Reference: 23082

Re: 54-58 Beaconsfield Street, Newport – Traffic Response to RFI

I have considered the relevant traffic and parking matters contained in Council's RFI (2023/1869) of 9 April 2024.

FIGURE B1 B99 (99.8TH PERCENTILE) VEHICLE

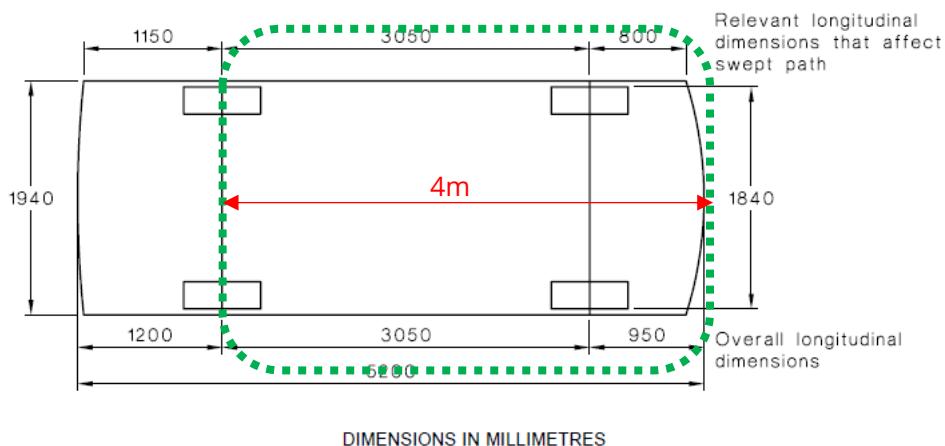
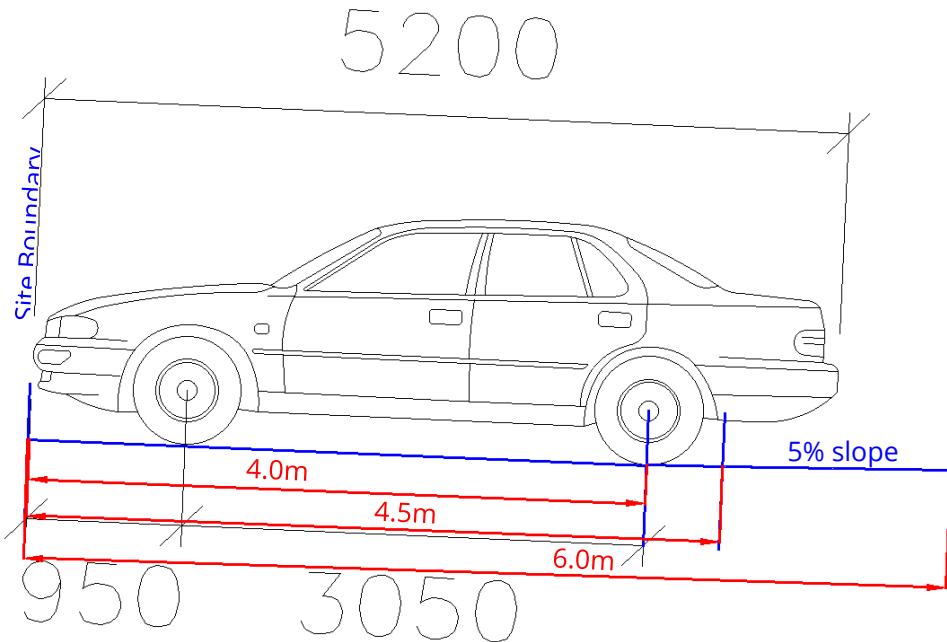
It is noted that the first ramp from the property boundary with a maximum of 5% slope is provided for 4m length instead of the required 6m. The required 6m should be available in accordance with AS 2890.1:2004, given the high pedestrian activity in the area and to allow a margin for driver error. Also, grade changes across a footpath and within the property, designed in accordance with AS2890.1 must be shown on the plans.

It is noted that the first 5m of the ramp is graded at 5%. This is less than the Australian Standards requirement of 6m.

The design intent of the 6m storage bay is to enable a departing car to stand on a relatively level surface such that its driver can see a pedestrian on/near the frontage footpath. However, the design vehicle is not 6m long; the Australian Standards' largest design light vehicle (a B99) is only 5.2m long. A template of this vehicle is extracted from the AS2890.1 and reproduced overleaf.

The B99 vehicle template indicates that the front of the car to the rear wheel is 4m long. On this basis, a 5m-long standing area will effectively allow a vehicle to stand on a uniform surface, as illustrated below:

Therefore, the provision of a 5m long ramp with a 5% grade will enable the departing driver's vehicle to stand on the same profile as it would on a 6m long ramp near the site boundary. Thus, the driver's sightlines towards pedestrians on/near the frontage footpath in both cases are comparable, and this meets the AS2890.1's design objective for pedestrian safety. It is noted that the majority of cars in Sydney metropolitan area is shorter than a B99 specification.

Swept Path Assessment

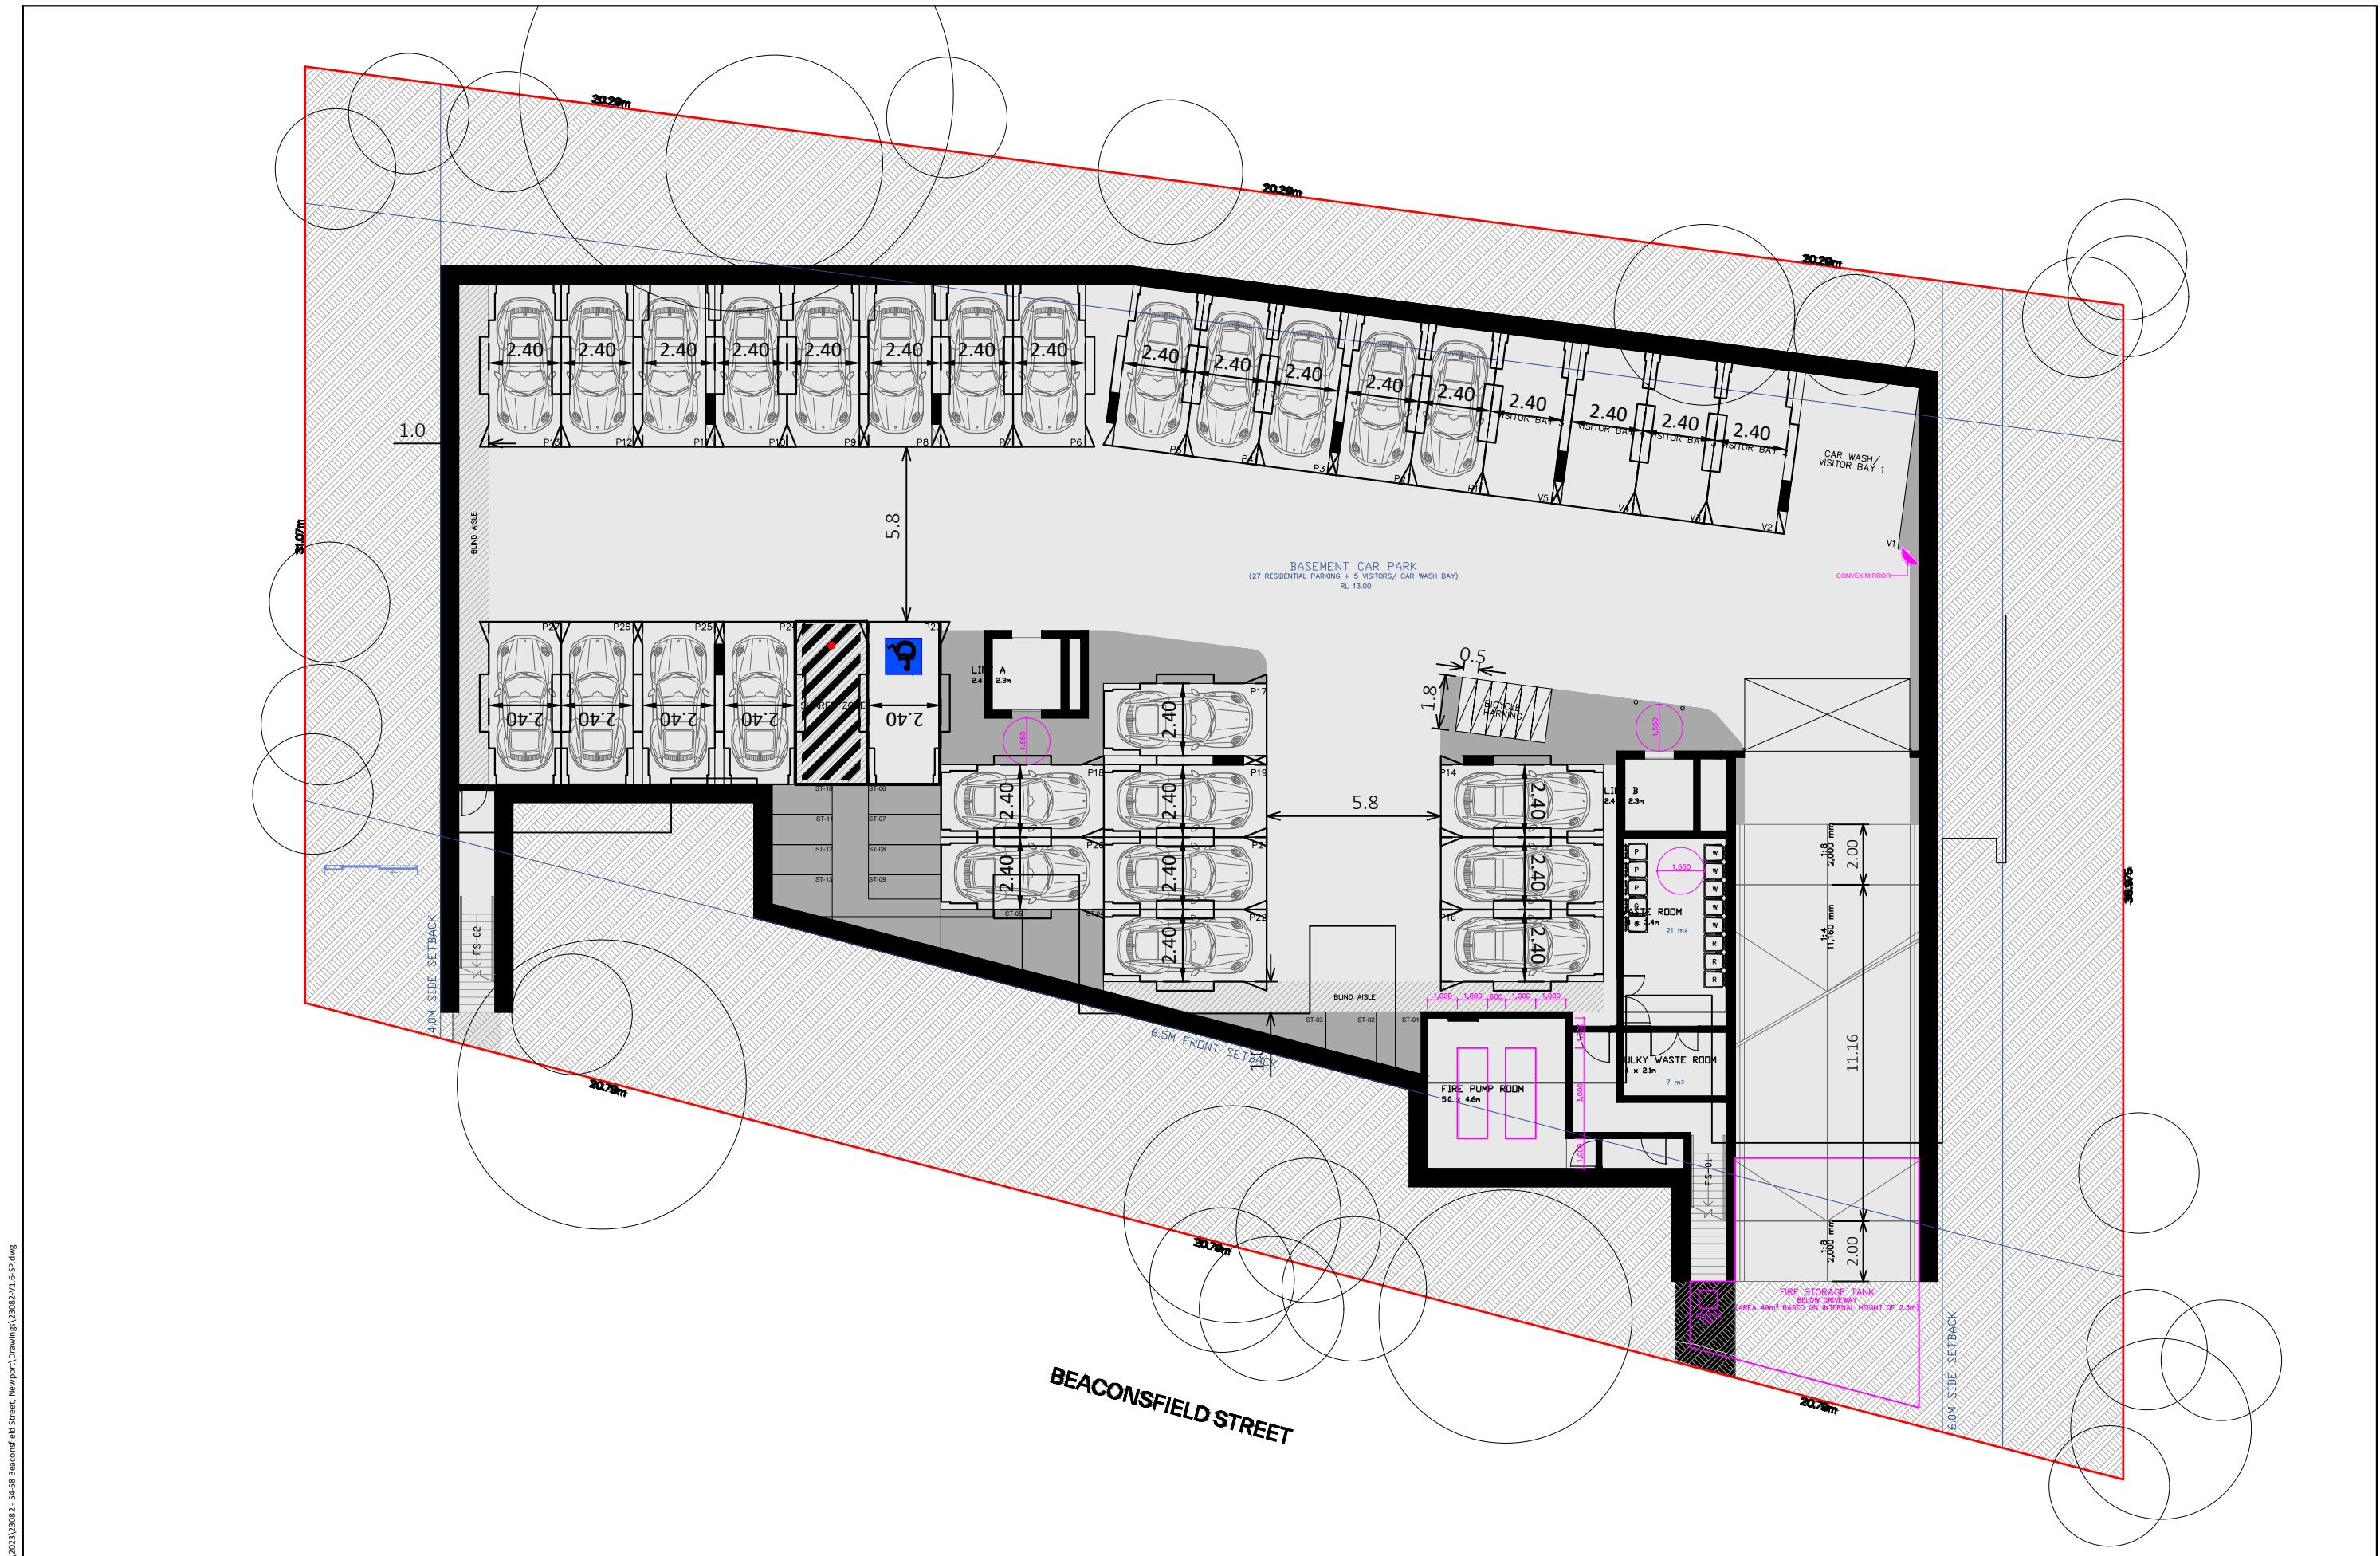
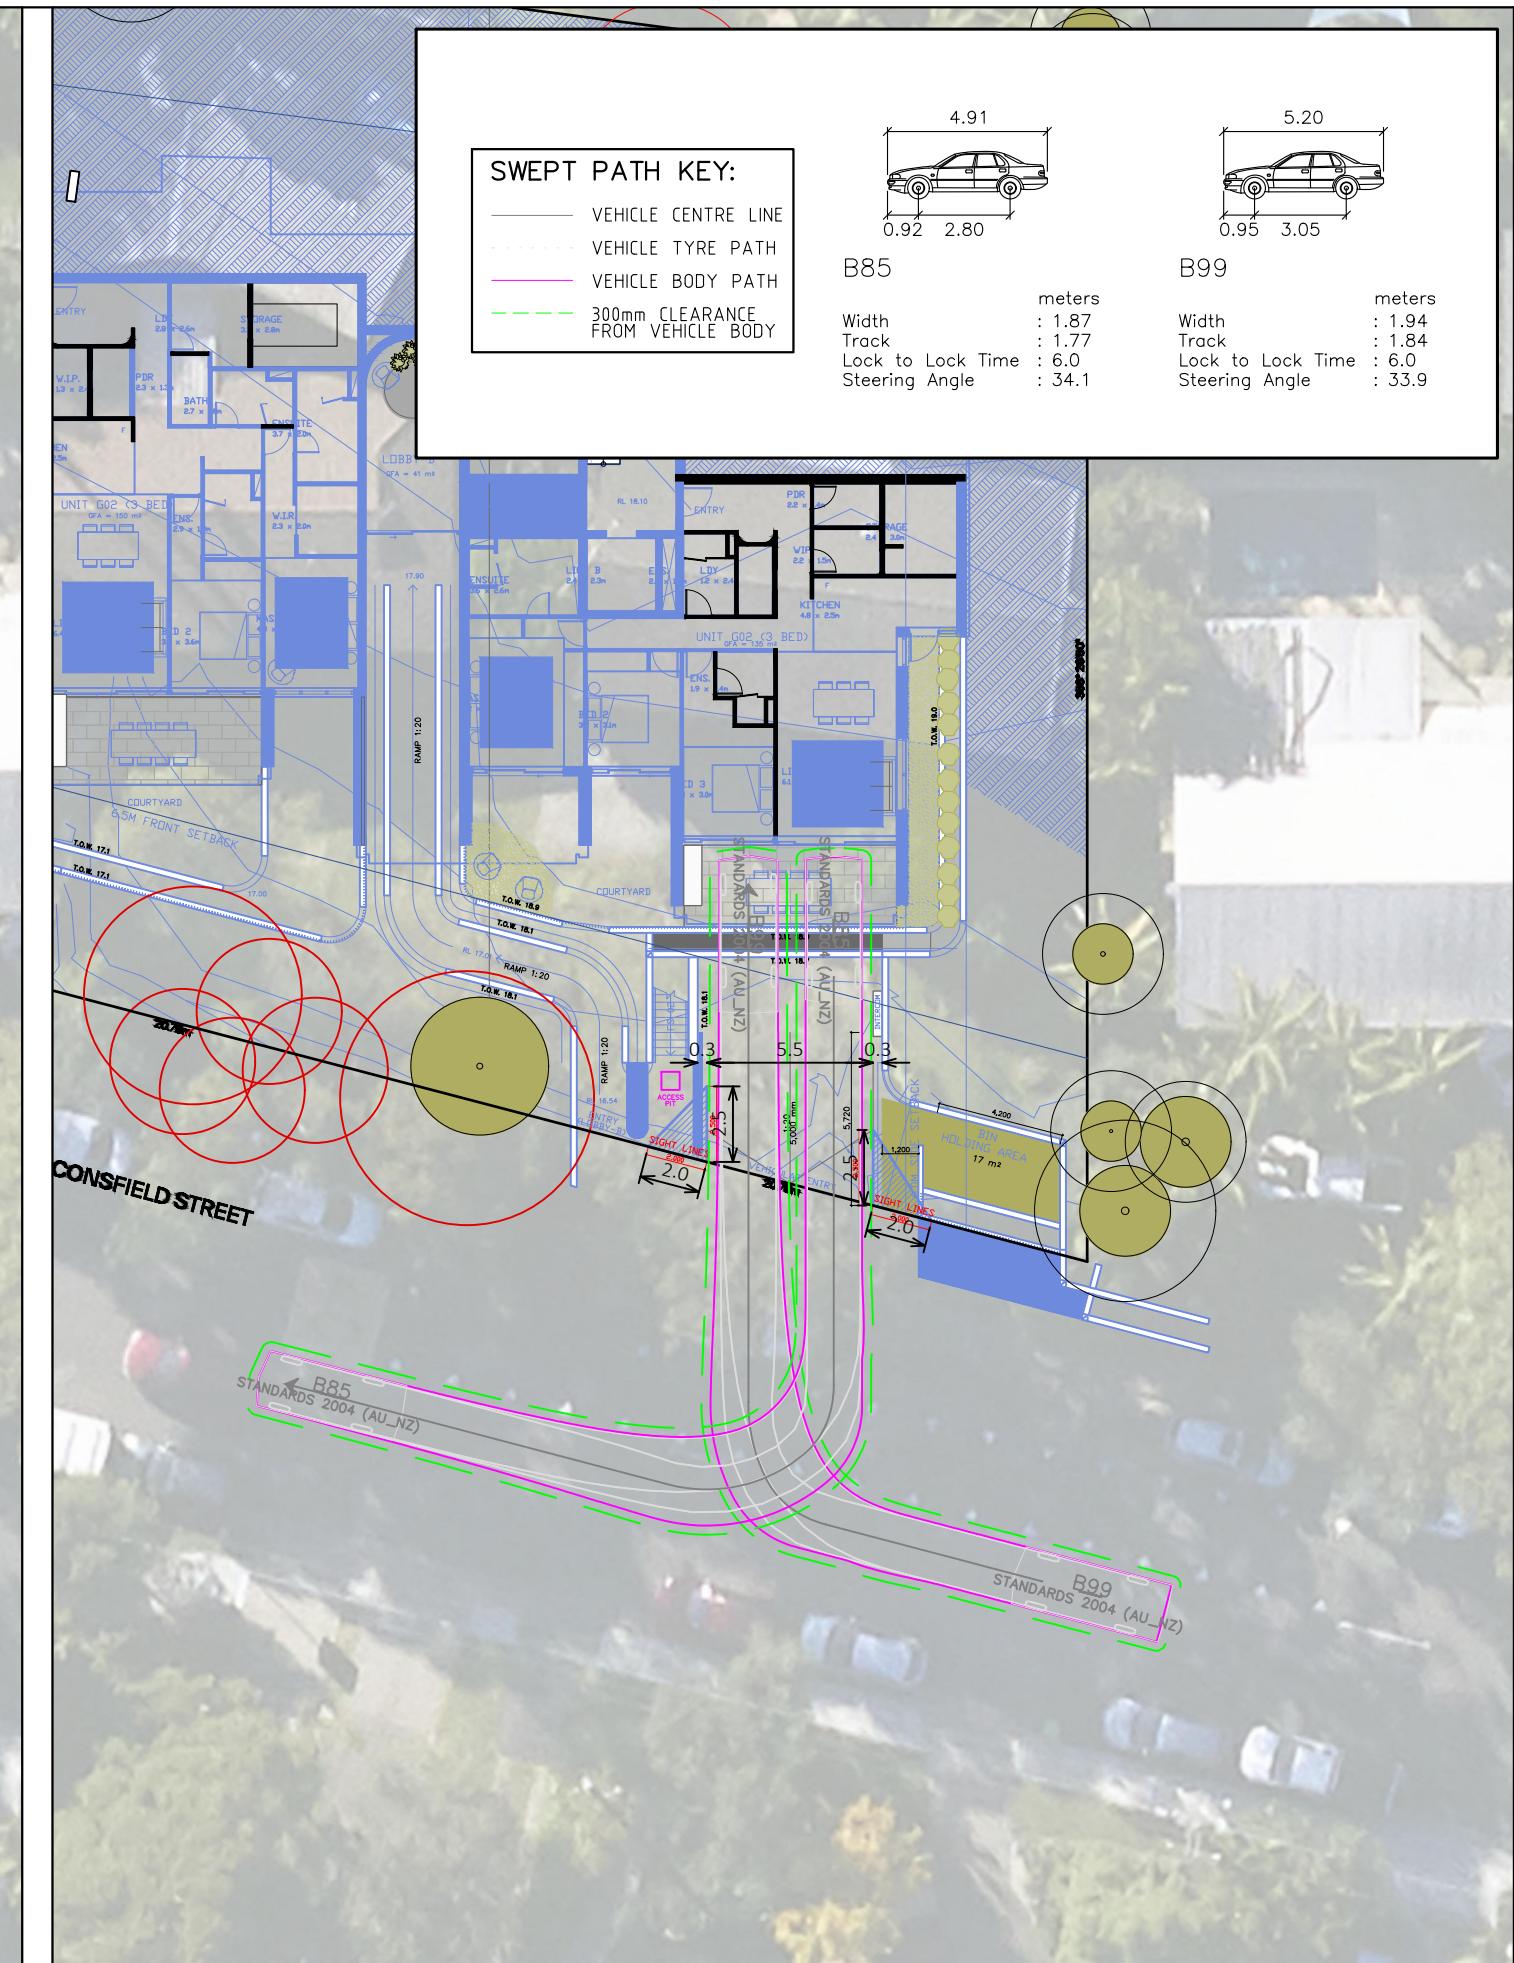
In page 28 of the Traffic Report, swept path for B85 passing B99 at the bottom of the ramp are overlapping each other. This means there is no passing achieved. Passing should either be achieved or if not possible, a stop holding line must be provided for vehicles exiting the basement, giving way to the entering vehicles. Swept paths must be amended and provided to Council's satisfaction.

In page 29 of the Traffic Report, a simultaneous passing of B85 and B99 is shown. However, the bodies of two vehicles are overlapping each other. This means there is no simultaneous passing achieved. This page should be amended for compliance with AS2890.1

The design did not intend for opposing vehicles to pass one another concurrently. For this reason, convex mirrors have been denoted on the plans, as is typical for residential car parks of this nature. The revised swept path diagrams appended to this statement indicate with clarity the available passing opportunity for vehicles in both directions.
